HISTORIC AND DESIGN REVIEW COMMISSION

HDRC CASE NO: 2015-427
ADDRESS: 516 E HOUSTON ST
LEGAL DESCRIPTION: NCB 423 BLK 24 LOT E 36 FT OF 2 OR A14
ZONING: D H RIO-3
CITY COUNCIL DIST.: 1
DISTRICT: Alamo Plaza Historic District
APPLICANT: Vince Cantu/I Carma LTD
OWNER: Cantu-Harwood, Inc
TYPE OF WORK: Exterior modifications

MOSES ROSE'S HIDEOUT
516 E. HOUSTON ST.

PROPOSED WORK

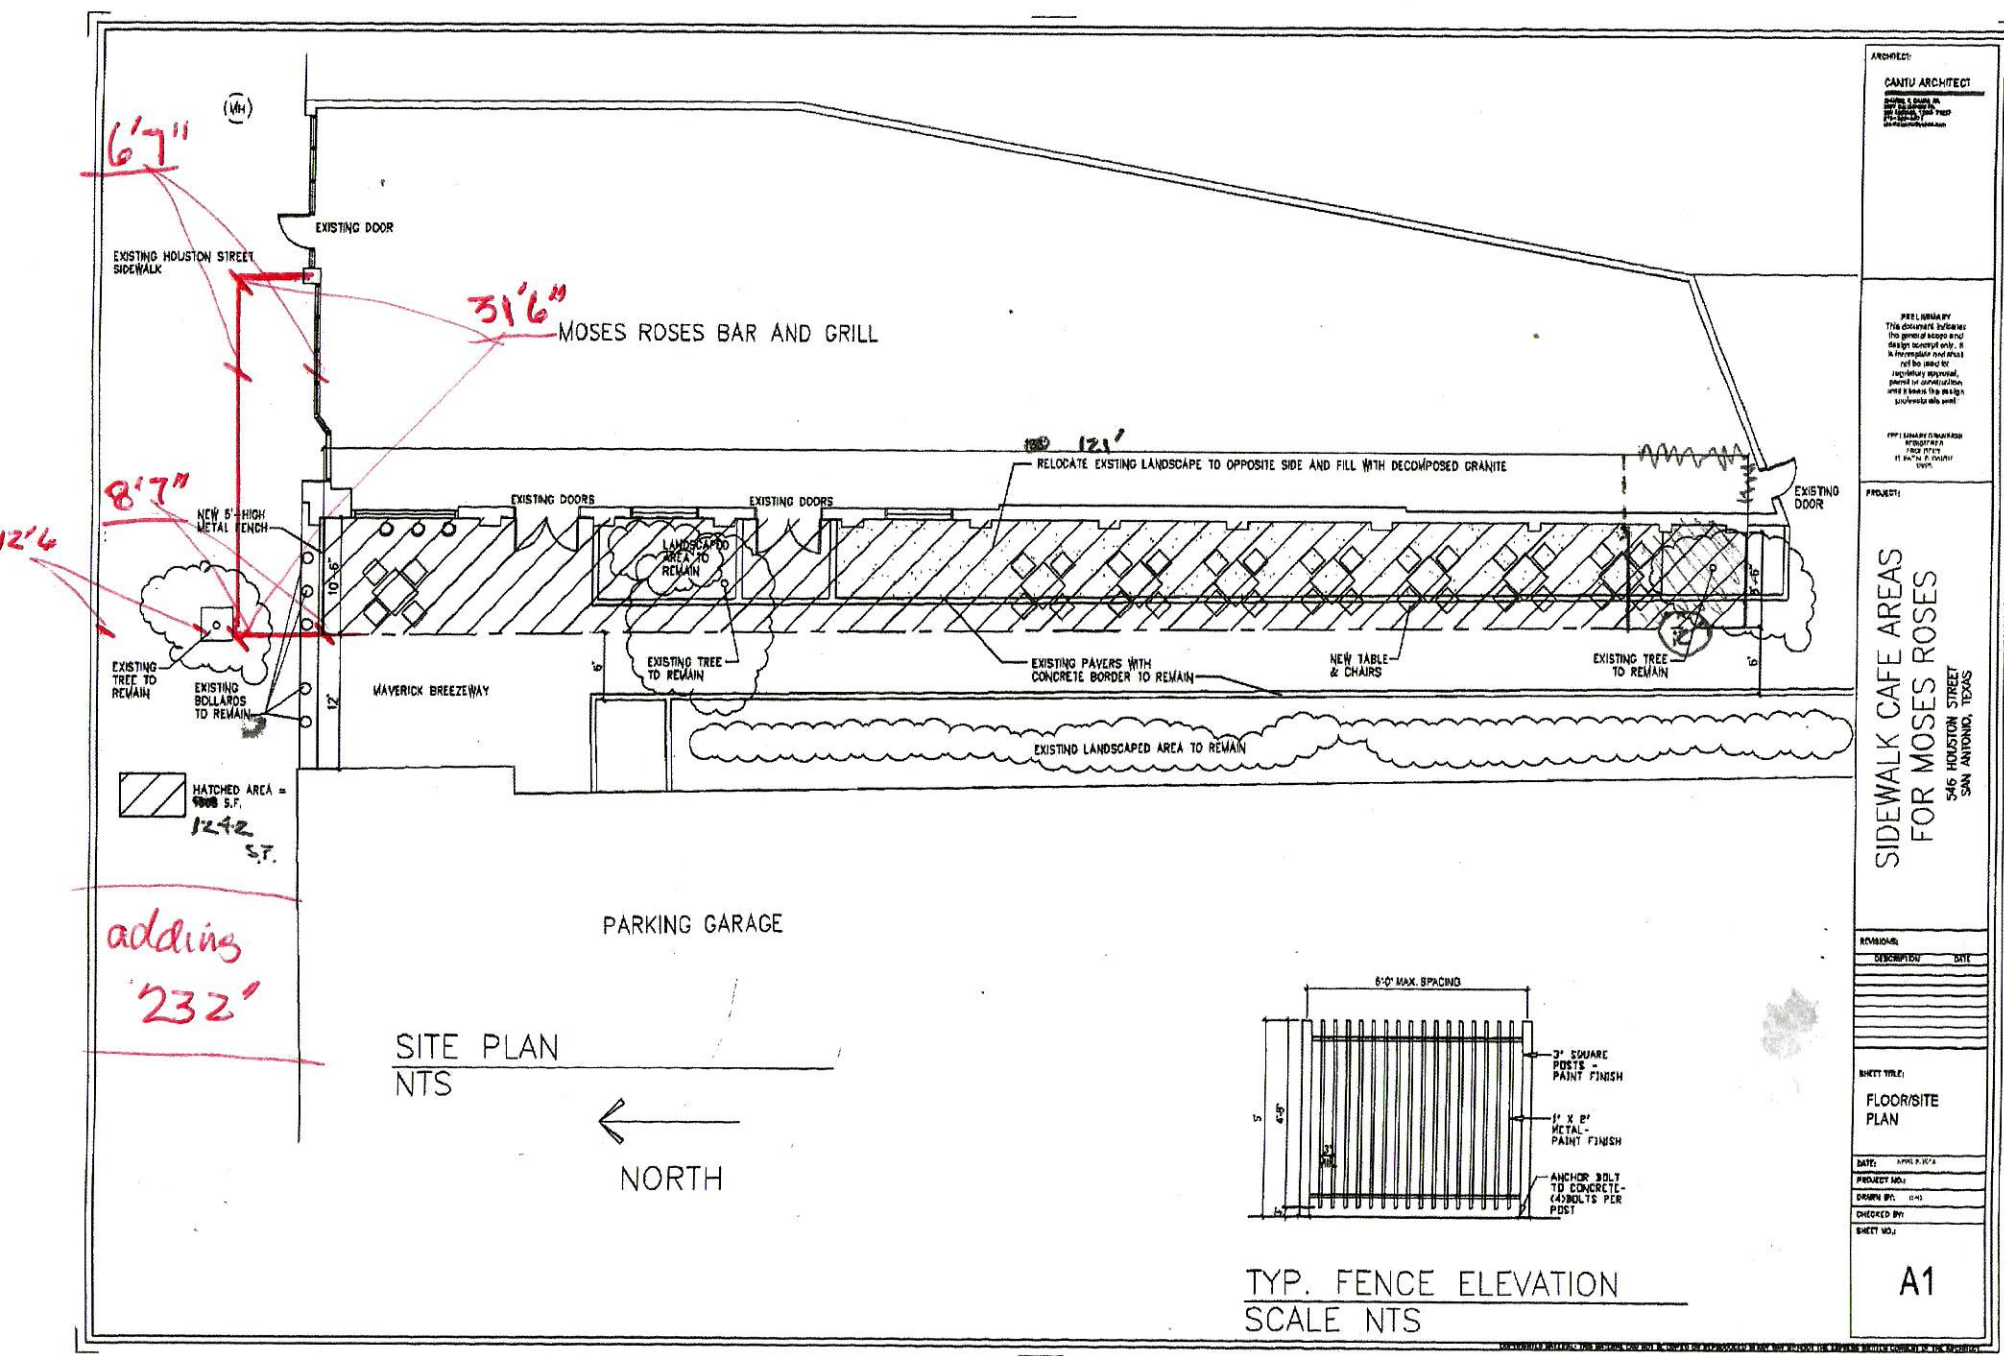
- c. The structure at 516 E Houston is a single story commercial structure which currently features an aluminum storefront system. The applicant has proposed to demolish this existing seventeen (17) feet wide storefront system and replace it with two, eight (8) feet wide , forty-two (42) inch tall countertops and two eight (8) feet wide, full view garage doors along the E Houston Street façade. The applicant has noted that the proposed garage doors will be aluminum overhead doors with clean anodized aluminum stiles and rails, matching the existing doors on the Maverick Breezeway façade. Per the UDC Section 35-674(d), materials that display a sense of human scale are generally appropriate. Staff finds the applicant’s proposal consistent with the UDC.

- d. Along the E Houston sidewalk, the applicant has proposed to install a forty-two (42) inch tall counter top table to extend 6’ – 7” onto the E Houston Street sidewalk to border a proposed outdoor patio area. The applicant has noted that the proposed counter top tables will be custom welded with custom wood countertops; matching the current counter top border in the Maverick Breezeway. While not on this block of E Houston, there are other examples of patio seating located along the E Houston Sidewalk. Staff finds the applicant’s proposed materials appropriate, however, the applicant is responsible for coordinating with the City of San Antonio’s Center City Development & Operations Department regarding the leasing of the sidewalk space.

- e. In the proposed new sidewalk seating area as well as in the existing Maverick Breezeway seating area, the applicant has proposed to install new custom welded tables. These tables will be replacing existing, concrete tables in the existing seating area. These tables will feature materials consistent with those proposed throughout this request, including custom wood countertops and custom welded tables and benches. The applicant’s proposal is consistent with the Guidelines for Site Elements 6.A.ii as well as the UDC Section 35-673.

- f. The applicant has proposed to install bicycle racks in the rear of the existing Maverick Breezeway patio area. According to the UDC Section 35-673(o), on site bicycle parking helps promote long term sustainable strategy for developments in RIO districts. The applicant’s proposed is consistent with the UDC, however, the applicant shall ensure that the area designated for bicycle parking is well lit and accessible.

Staff recommends conceptual approval as submitted based on findings a through d.
